White Paper

Correcting the inappropriate noise impact conclusions of Massport's environment disclosures regarding Hanscom Field

Updated February, 2023

Figure 1: Scale of DNL with regulatory citations and reference values

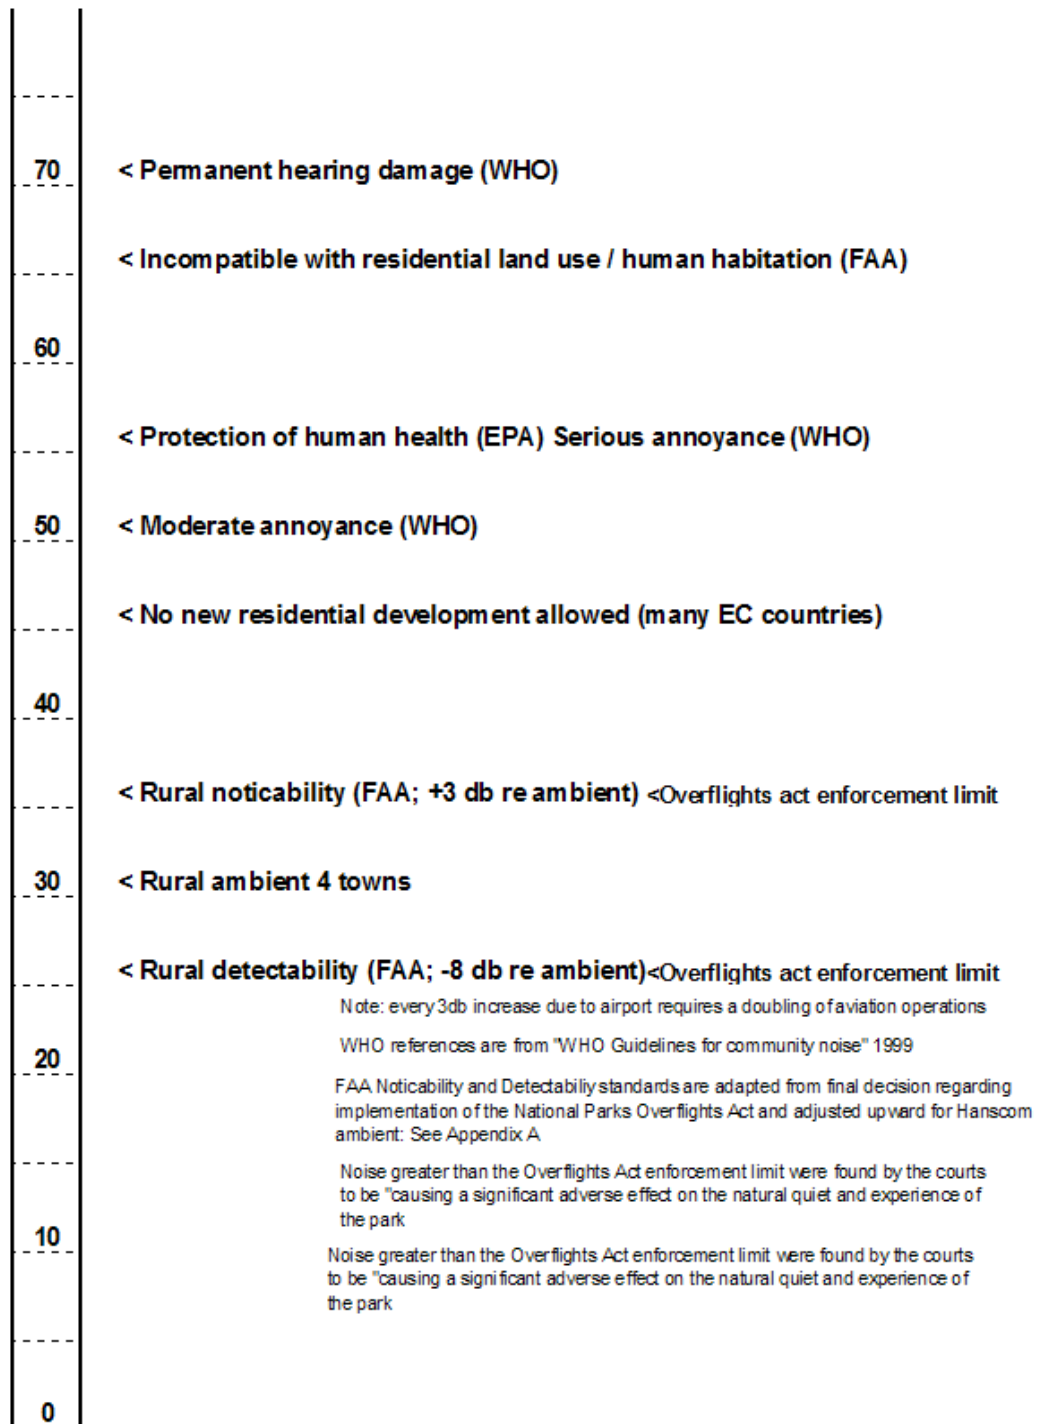
Placing DNL values in perspective It is helpful to put the 65db DNL criteria into context. In Figure 1, a vertical scale of DNL values is annotated with various regulatory thresholds.

Hanscom would need to go to 1,600,000 operations before the sites currently experiencing 55db DNL would experience the 65db level that Massport claims should be used as the criteria for impact. This would be almost 3 times the number of operations of Logan Airport. Arguing that this is the criterion for "significant impact" is not sane or reasonable.

The ESPR uses a criteria which is only 5db away from the level which the WHO classifies as the level at which the onset of hearing damage begins. It is 15db, or 30 times higher in

noise energy, than the 50db standard which is prescribed by scientific and regulatory bodies for rural residential environments.

Furthermore, the use of the 65db DNL criteria for significant impact in National or State Parks and Wildlife Refuges is completely inconsistent with any regulatory standard and is much higher than even the only FAA regulation for noise in a National Park.

Figure 2: Noise impact area using the TA method

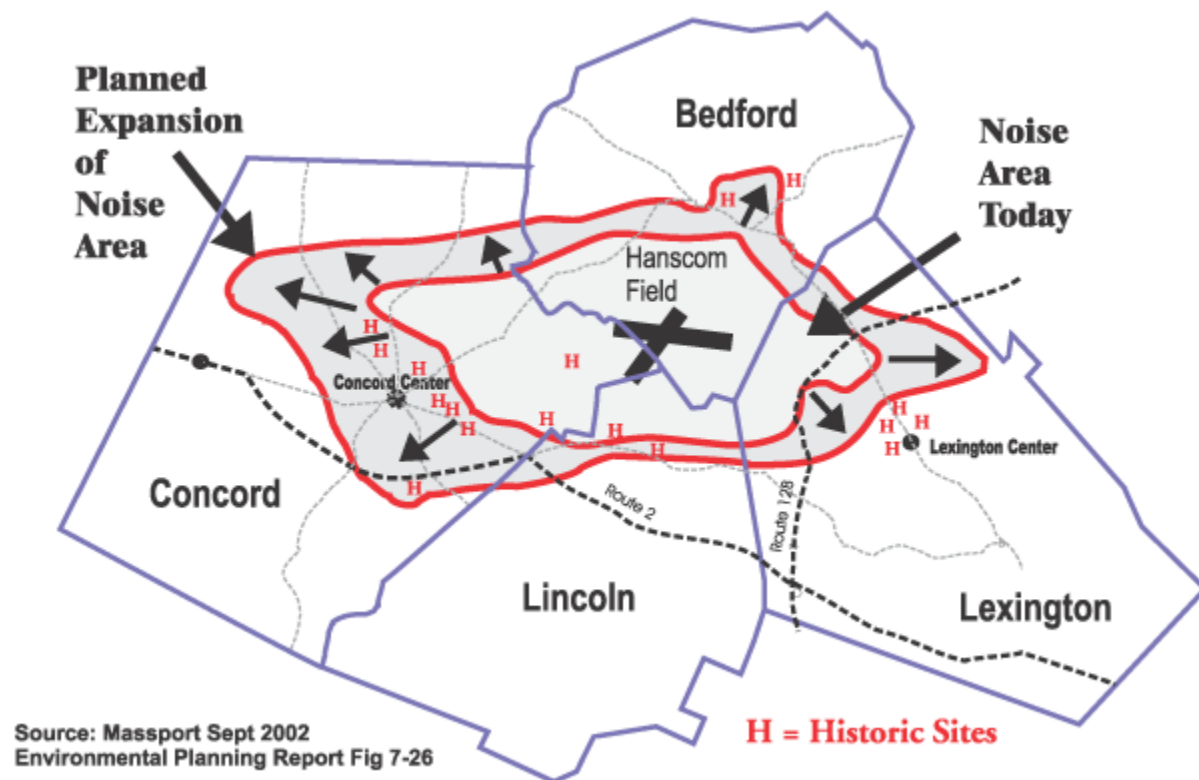
Figure 2 shows that Massport's own data using the TA method show that the noise impacts on Historic sites will be increased significantly under Massport airport growth plans. This figure was generated by the noise report in 2002. It is not current, but can still be

generated any time Massport runs the noise model, but Massport has declined to produce it in subsequent reports.
